## ADDENDUM #1

### NOTICE TO ALL BIDDERS FOR CITY OF WINCHESTER

#### ITB #202004 – Pennsylvania Avenue and Conway Wastewater Pump Stations Replacement

ADDENDUM NO. 1	DATE 03-10-20	CITY OF WINCHESTER WINCHESTER, VIRGINIA	HAZEN JOB NUMBER 31294-007/014	REFER TO CONTRACT DRAWING NUMBER C5-C
ATTACHMENT NO. 1	BY JKP	PENNSYLVANIA AVENUE AND CONWAY WASTEWATER PUMP STATIONS REPLACEMENT	CONTRACT NUMBER #202004	SHEET 1 OF 1

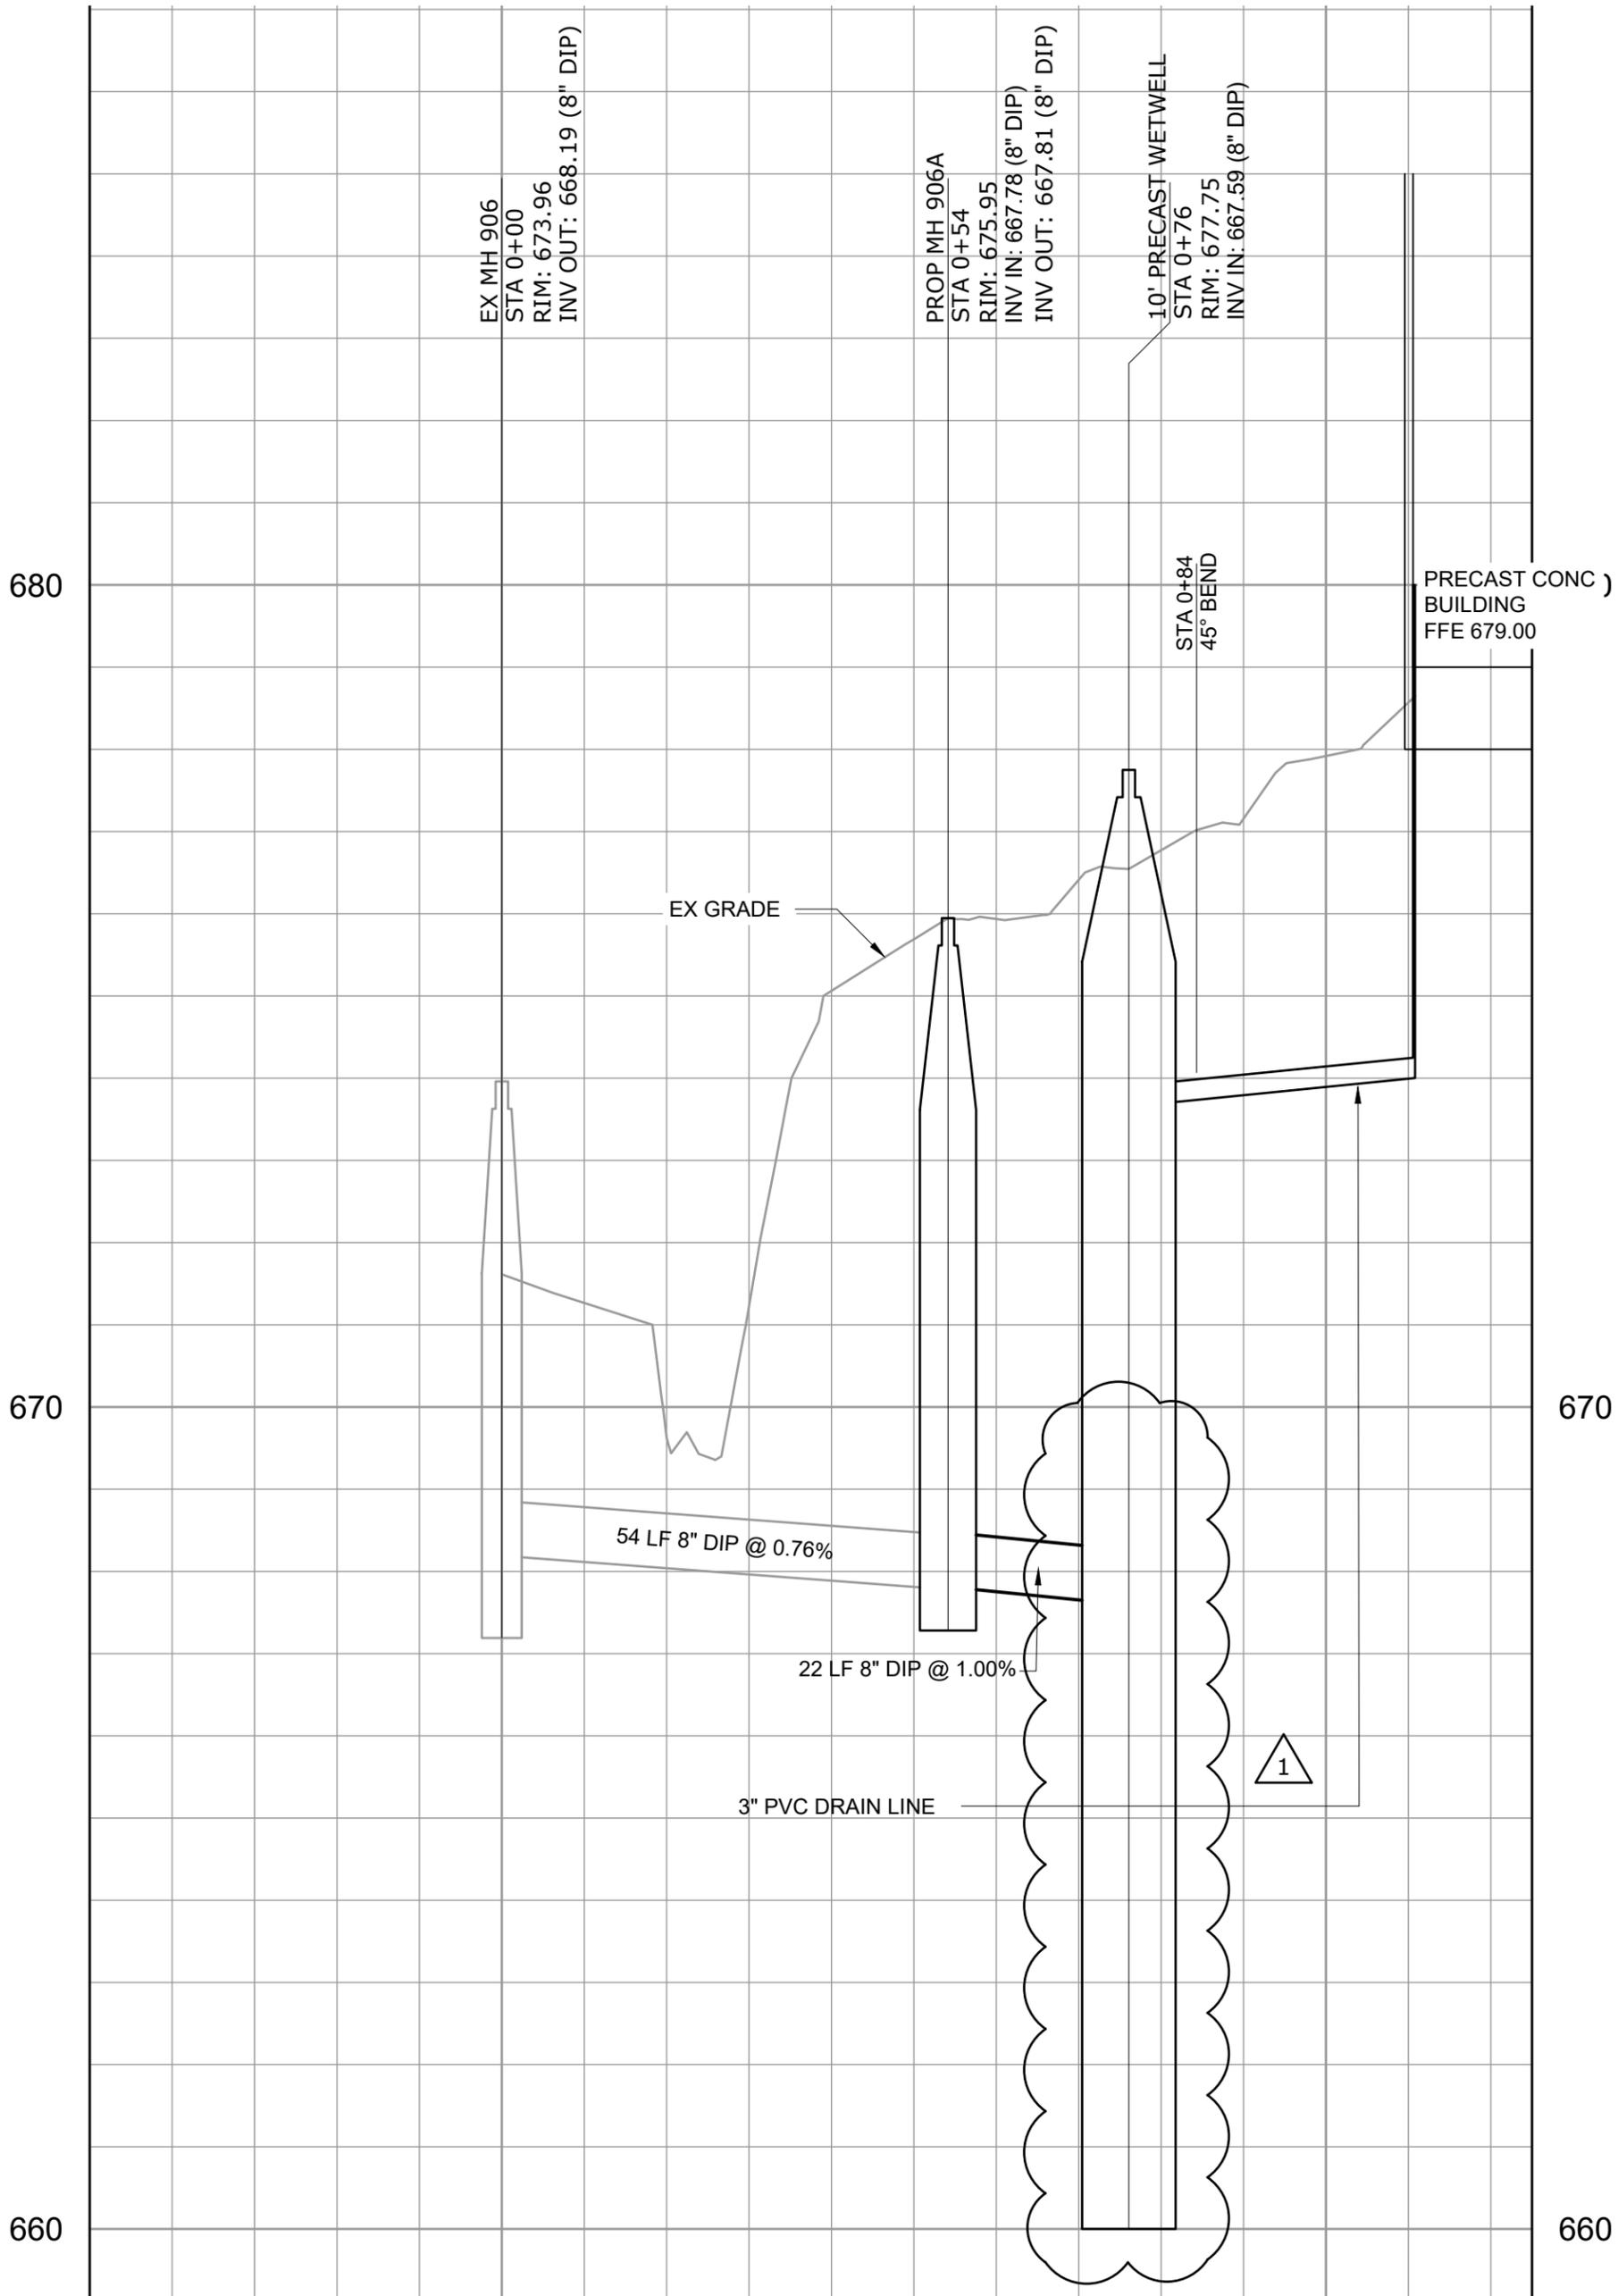
1. Drawing S1-P, Bottom Plan, **Delete** 19'-6" dimension and **Add** 18'-6" dimension
2. Drawing C5-C Shall be modified with Attachment 1 made part of this Addendum.

**PROFILE 1**  
H: 1"=20' V: 1"=2'
